Burston Garden Retirement Village

Design and Access Addendum - Landscape

Planning Application Reference: 5/2018/1324

AL6903 / Planning Addendum - Landscape 20181023

Illustrative section A-A' through the Burston Gardens Care home boundary with hornbeam hedge and railings

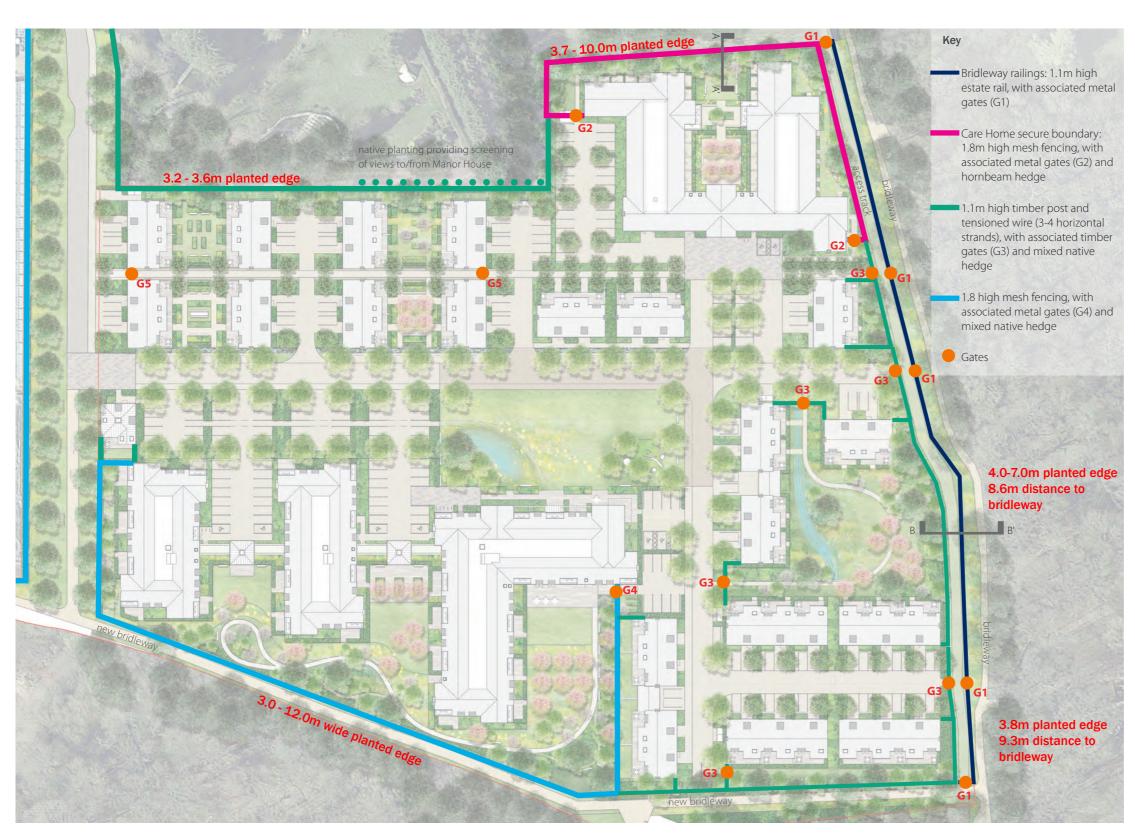
Along the care home and assisted living boundaries the native hedge is planted adjacent to a 1.8m high fence providing a secure boundary. The proposal is to replace the previously proposed metal vertical railings with a metal mesh fence which will visually recede into the hedge.

1. Care home and Assisted Living secure boundary railings replaced with mesh fencing, to provide a green screen and secure boundary.

## The Village Green (Addendum)

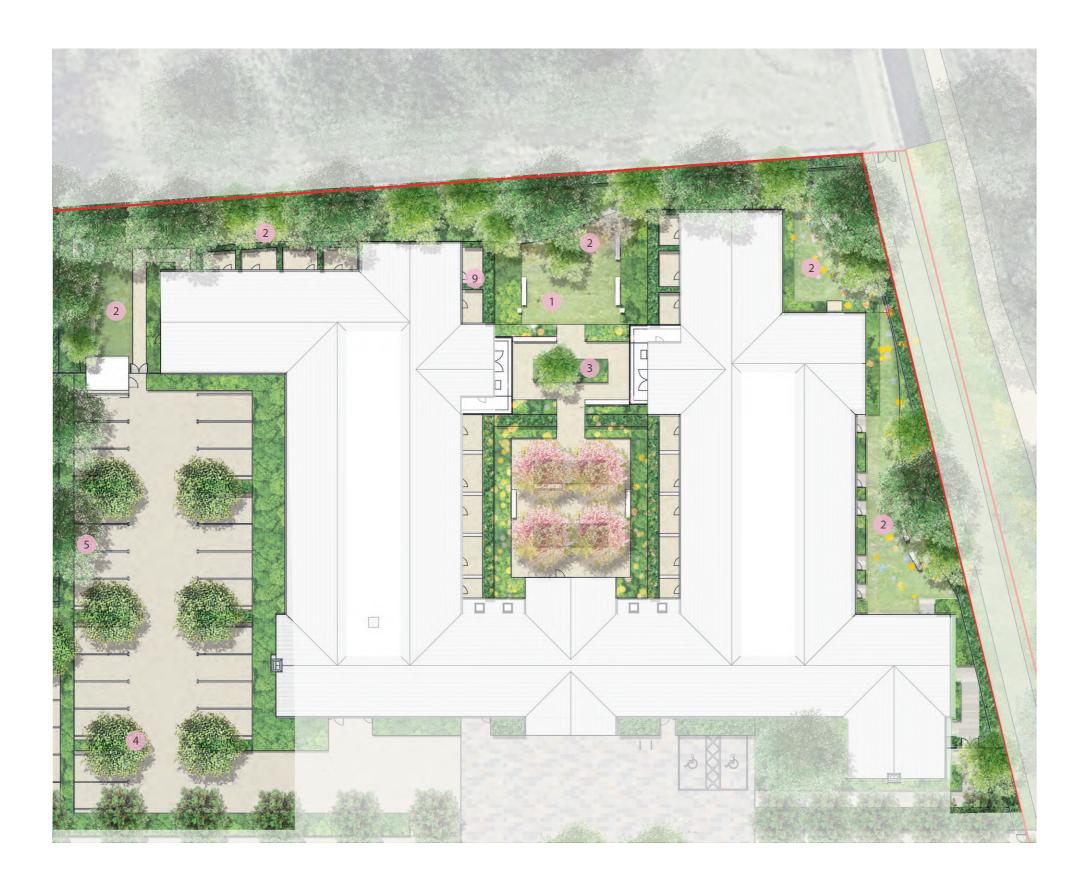
- 1. The Green is extended to the west, enlarging the accessible open space, 66m x 27m (1780 m2);
- 2. Entrance drive removed and replaced with tree planting;
- 3. New drop off area provided;
- 4. Redesigned pond with informal tree planting;
- 5. Trees removed from northern edge of green, extending the green and opening up the space to the north.

# **Communal Gardens - Care Home Sensory Gardens**

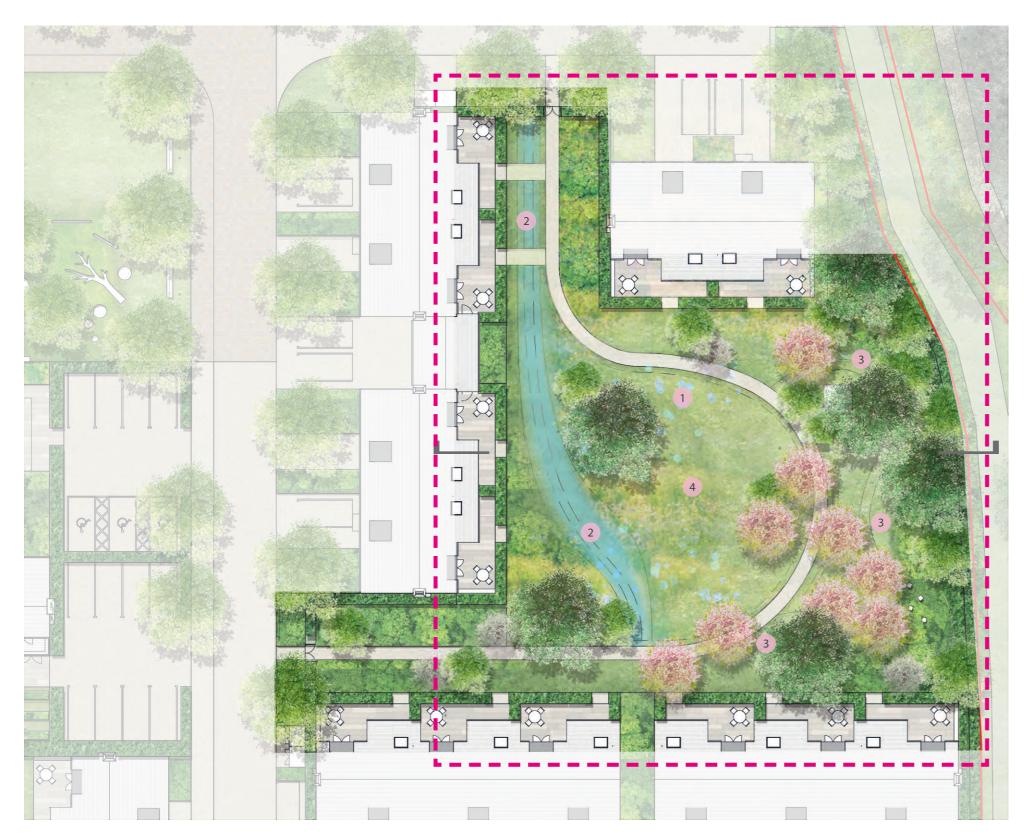
- 1. Reduction in hard paved area;
- 2. Paved routes through garden reduced and replaced with more informal lawns and planting;
- 3. Reflecting pool omitted and replaced with raised planters and seating;
- 4. Parking layout reconfigured to provide additional tree planting;
- 5. Column lighting removed from boundary with Manor House.
